June 17, 2008

TO: Columbia River Crossing Task Force
FROM: CRC Pedestrian and Bicycle Advisory Committee (PBAC)
SUBJECT: PBAC Recommendations for World Class Pedestrian and Bicycle Facilities

The I-5 Bridge Must Include a “World-Class” Pedestrian and Bicycle Facility

PBAC Proposed Pedestrian and Bicycle System for Replacement Bridge

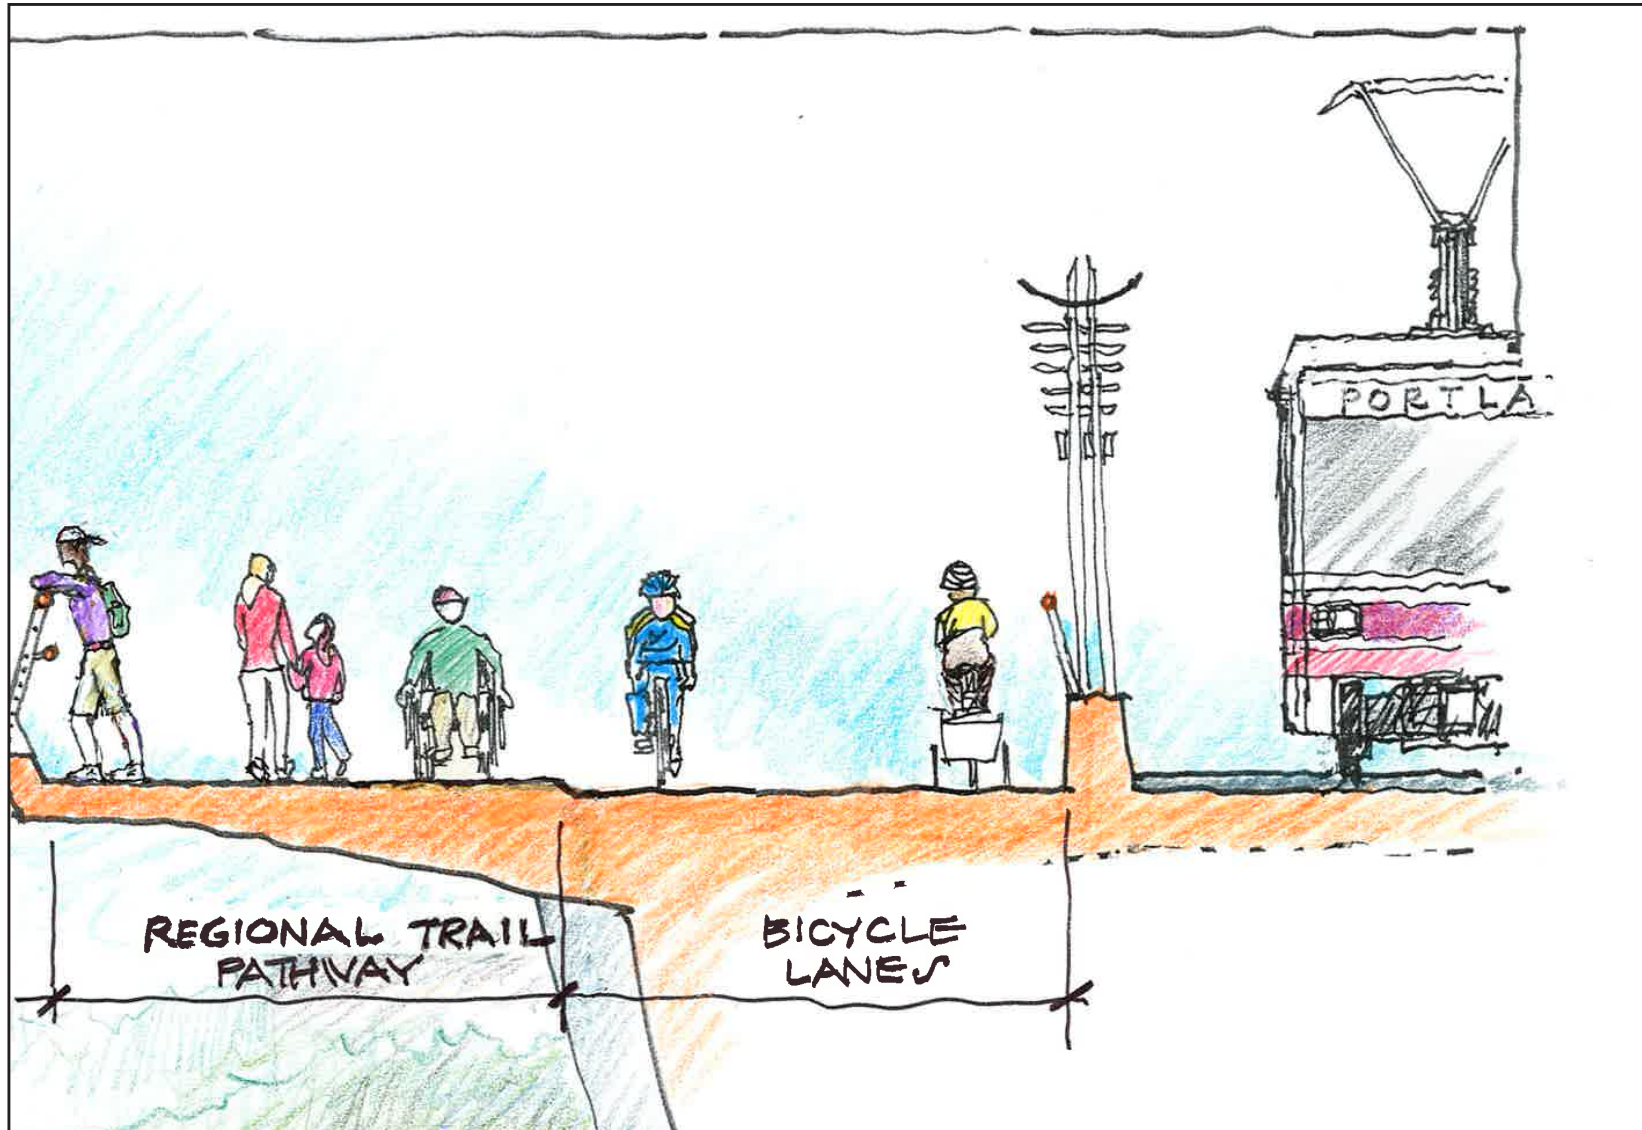
- The overall pathway on the western bridge (adjacent to the transit guideway) must provide separation between recreational users and higher speed bicycle users. To provide this separation, a 12-foot wide regional trail should be provided adjacent to, and to the west of, a pair of six-foot wide bicycle lanes (see attached rendering). These recommended widths are exclusive of potentially needed shy distances, i.e., free and clear of poles and other obstructions to enable safe pedestrian and bicycle movement (a summary of agency standards for multiuse paths, sidewalks and bike lanes is attached).

The regional trail would accommodate pedestrians, persons with disabilities, seniors, families with children, tourists, roller-skaters, and recreational bicycle riders. The adjacent bicycle lanes would be used by bicycle commuters and other faster-moving bicyclists. The regional trail would be at a slightly higher level than the bicycle lanes, but bicyclists in the bicycle lanes would be able to access the trail. Different paving treatments and/or patterns should differentiate the regional trail and the bicycle lanes.

- In addition to the combined regional trail and bicycle lanes on the western bridge, an eight-foot wide sidewalk should be provided on the eastern bridge (the bridge that would serve the northbound traffic lanes) across both the Columbia River and the North Portland Harbor. The sidewalk across the North Portland Harbor would touch down on Hayden Island and use surface street sidewalks to connect to the sidewalk across the Columbia River.
